BURBANK 2017 WASTEWATER CHANGE PETITION

Initial Study/Negative Declaration

Prepared for
City of Burbank

August 22, 2017

Figure A-7
BWRP Discharge Summary 1991-2025

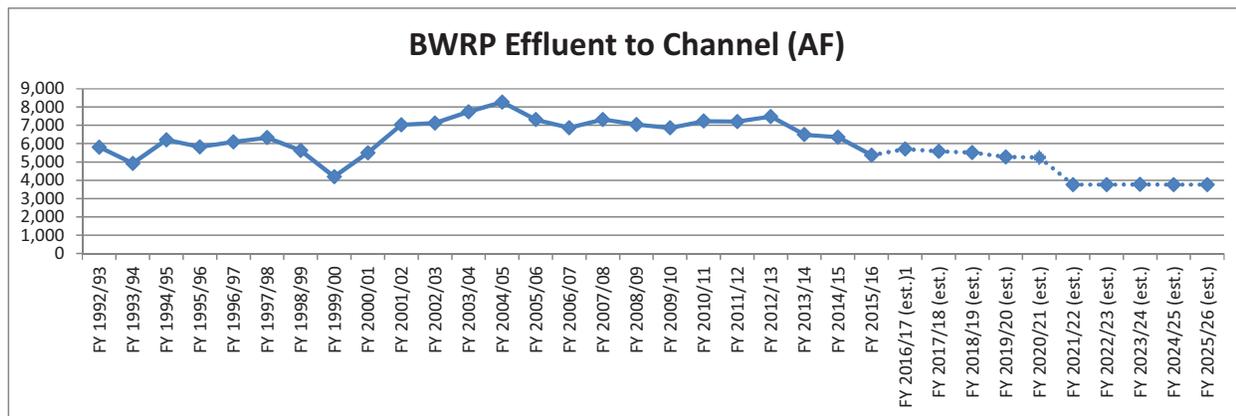
1. Attachment A. Project Description (Page 10) and FIGURE A-7

"As a result of increased demand for recycled water, Burbank is proposing to gradually increase its use of recycled water from 2,705 Acre-Feet (AF) to approximately 5,027 AF by 2025 (see Figure A-7)."

Comment: The reduction in flow is characterized throughout the IS/ND as "gradual." However, according to Figure A-7, there is nearly a 30 percent reduction in total discharge from FY 2020/2021 to 2021/2022. The entire proposed reduction occurs in a single year and is therefore not gradual.
